Response to Referee 1 Comments on:

Influence of building collapse on pluvial and fluvial flood inundation of metro stations in central Shanghai

Response to Referee 2 Comments on:

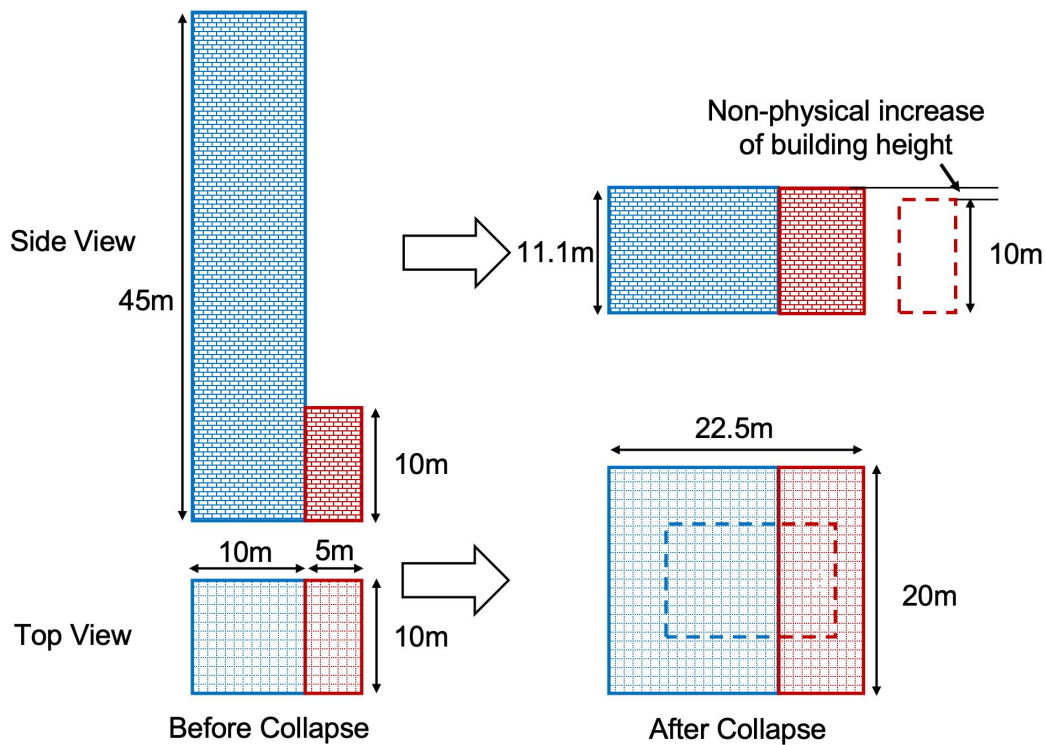
4. Line 140: Provide more information on the collapse mechanism. Although the model is cited, it would be helpful to provide a few more details on the adopted collapse mechanism. For instance, how is the presence of nearby buildings considered? How far do the debris reach?

Response: We have provided more detailed description of the building collapse mechanisms and the estimation method considered in our analysis, including the treatment of nearby buildings. We have added a new figure to assist the illustration:

“building collapse is modeled by distributing certain amount of the ‘‘building material’’ to its surroundings, thereby increasing the spatial occupancy and reducing the height of the building. In this study, we assume that when a building collapses, (i) its spatial occupancy doubles, and (ii) its total volume remains unchanged. The increased spatial occupancy (i.e., the ‘‘debris’’) is distributed uniformly around the building. The reduced height of the building can be estimated using the volume and the new spatial occupancy. A special case exists when two buildings are adjacent and their spatial occupancy overlap when collapsed. In such situations, the two buildings are treated as one single building when calculating the debris extent. It should be noted that if two buildings with different heights are treated as one building, the final building height after collapse could be greater than its original height, which is unrealistic (Fig.3). However, this phenomenon has negligible influence on the subsequent flood simulation because as long as the building debris is not inundated, slight variation of its height has minor influence on the flow field. That is, the

obstruction of the flow path (due to the spreading of the debris extent) has much stronger influence on flood propagation than minor changes of the debris height. With this approach, building collapse is only a simplified representation of the consequence of hypothetical seismic events, but the physical mechanism connecting earthquake and building collapse is not involved.

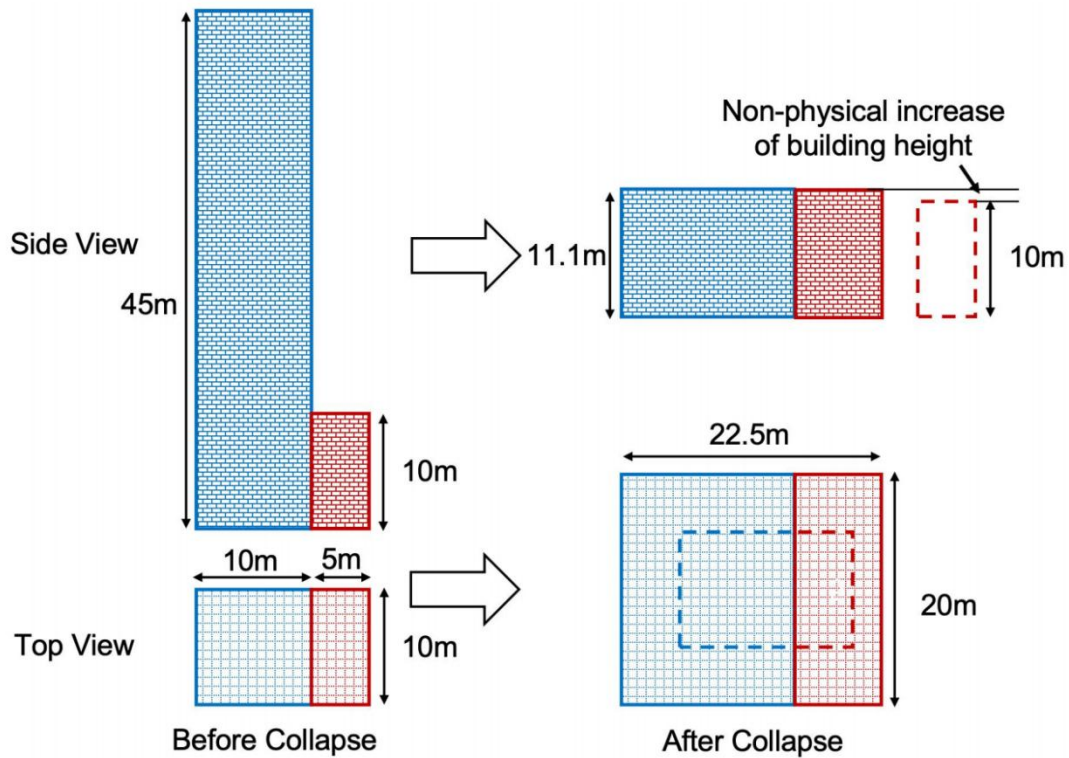
3. 141: The sentence does not become clear, more explanation is required.

chap. 2.3: what happens during collapse is not fully clear; better description or a figure where 1 building is shown before and after collapse, give length, width, height, volume etc.

Response: The third and fourth comments are both related to the description of the building collapse mechanism. We have revised Section 2.3 and added a figure to address the reviewers' concerns :

“building collapse is modeled by distributing certain amount of the “building material” to its surroundings, thereby increasing the spatial occupancy and reducing the height of the building. In this study, we assume that when a building collapses, (i) its spatial occupancy doubles, and (ii) its total volume remains unchanged. The increased spatial occupancy (i.e., the “debris”) is distributed uniformly around the building. The reduced height of the building can be estimated using the volume and the new spatial occupancy. A special case exists when two buildings are adjacent and their spatial occupancy overlap when collapsed. In such situations, the two buildings are treated as one single building when calculating the debris extent. It should be noted that if two buildings with different heights are treated as one building, the final building height after collapse could be greater than its original height, which is unrealistic (Fig.3). However, this phenomenon has negligible influence on the subsequent flood simulation because as long as the building debris is not inundated, slight variation of its height has minor influence on the flow field. That is, the obstruction of the flow path (due to the spreading of the debris extent) has much stronger influence on flood propagation than minor changes of the debris height. With this approach, building collapse is only a simplified representation of the consequence of hypothetical seismic events, but the physical mechanism connecting earthquake and building collapse is not involved.”
